DATE 13 April 2022
PROJECT Wind Garden and Fronteer WEFs
CLIENT Savannah Environmental

CULTURAL LANDSCAPES COMMENT ON REVISED LAYOUT FOR PROPOSED WIND GARDEN AND FRONTEER WEFs (18 March 2022)

Figure 1: Cultural Landscapes map showing recommended buffers as per June 2021 specialist reports with revised proposed layout of turbines and access roads (March 2022). Only the three turbines marked in green are acceptably located in terms of the CLA buffers.

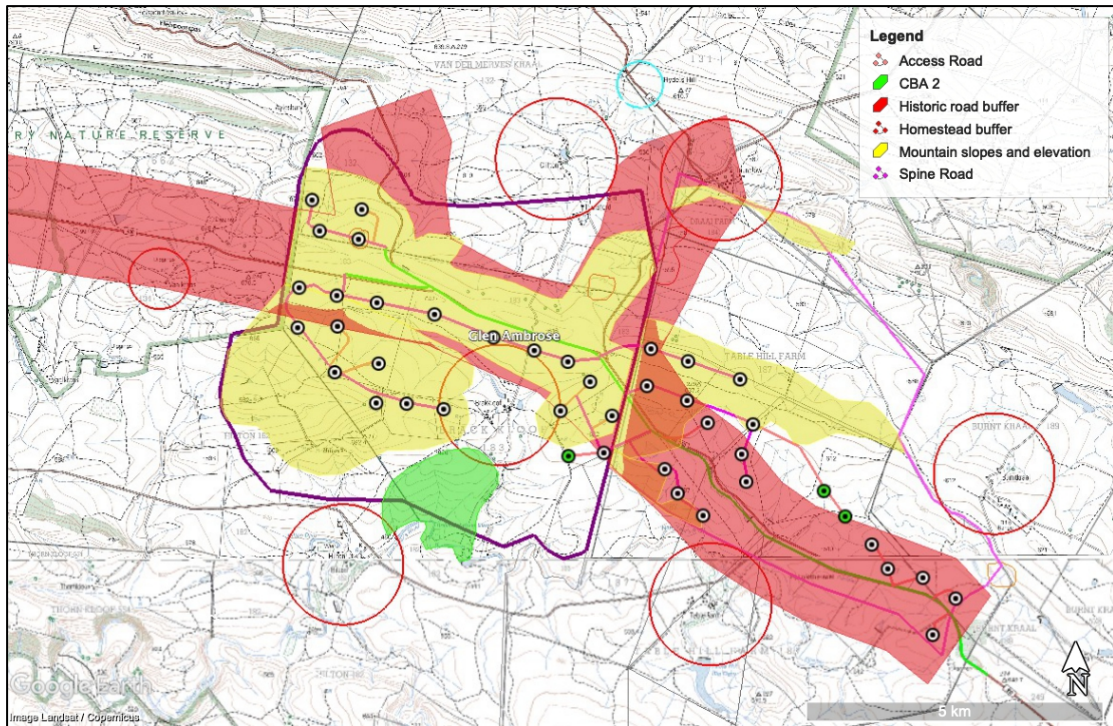
1. The revised proposed layout does not adhere to the cultural landscapes buffers and recommendations as submitted in the Cultural Landscapes Assessment reports submitted June 2021. Please see attached map for CL buffers with optimised layout overlay.
2. The optimised layout does not change the findings of the original specialist report as provided.
